**ADDENDUM
(FINAL ENVIRONMENTAL IMPACT STATEMENT)**

**Decommissioning of Eight
Surplus Production Reactors
at the Hanford Site,
Richland, Washington**

December 1992

U.S. DEPARTMENT OF ENERGY

Figure 3-27. Flooded area for the probable maximum flood (after ERDA, 1976).

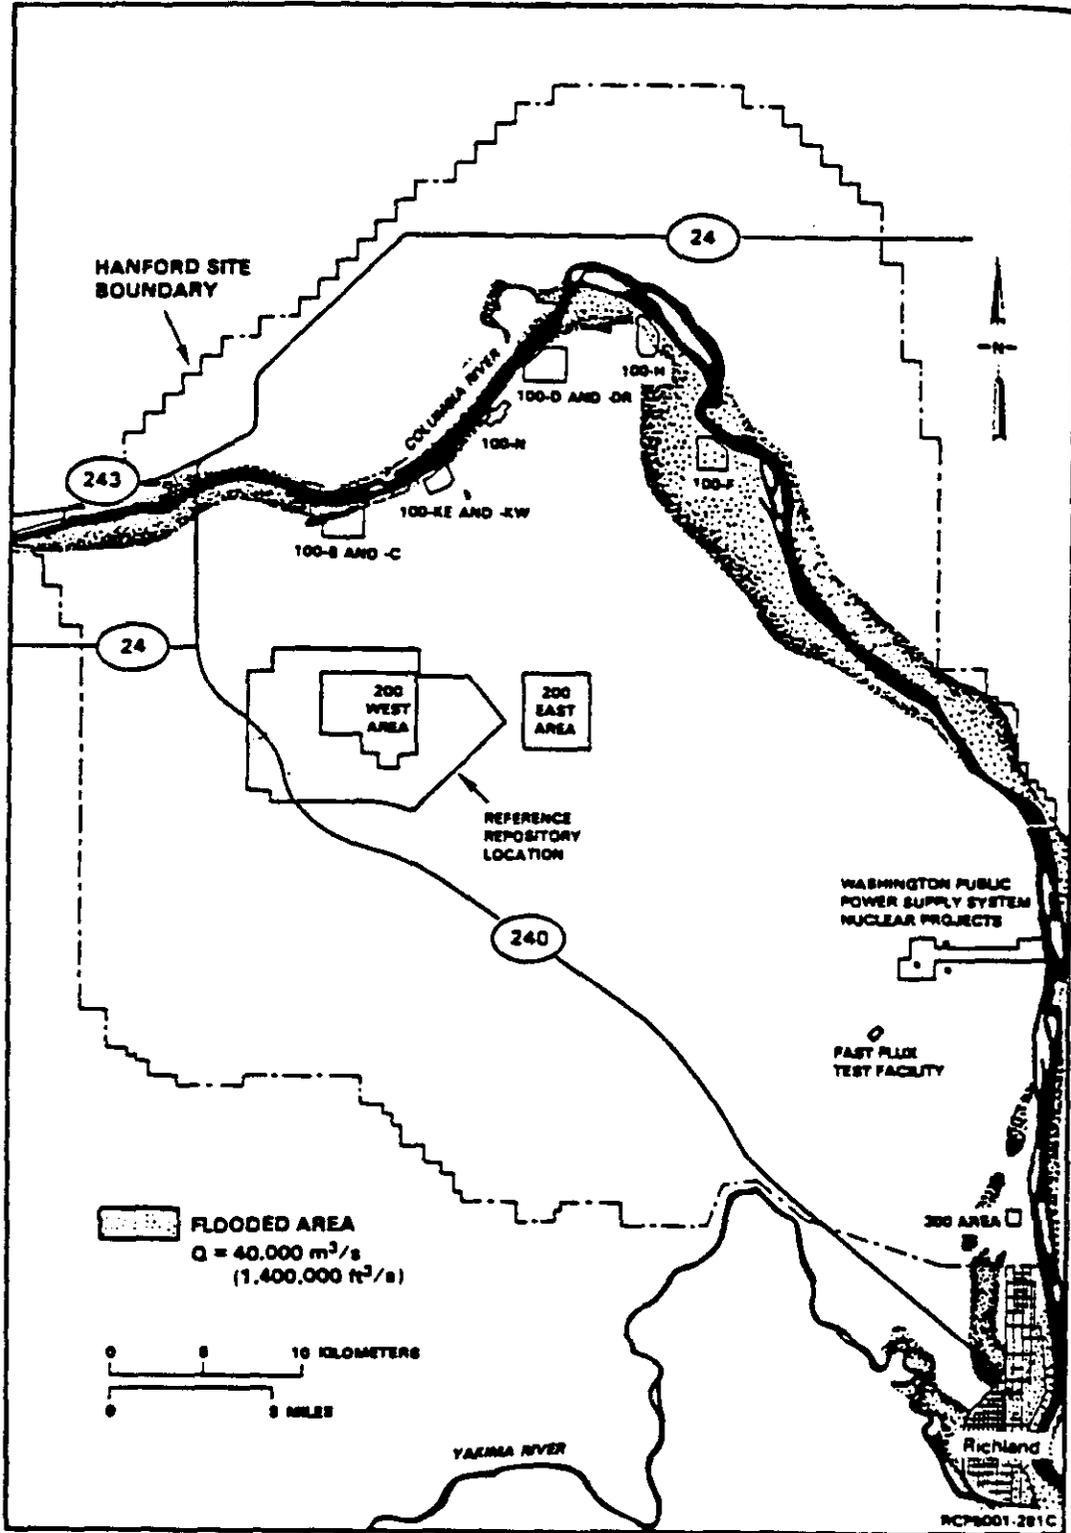
Page A.16 - Because masonite and transite are no longer in today's lexicon, the text should give a brief description of each product.

Page A.28 - The final EIS should explain why certain facilities listed in Table A.12 do not contain cadmium but on page 3.4 it states cadmium is alloyed with lead.
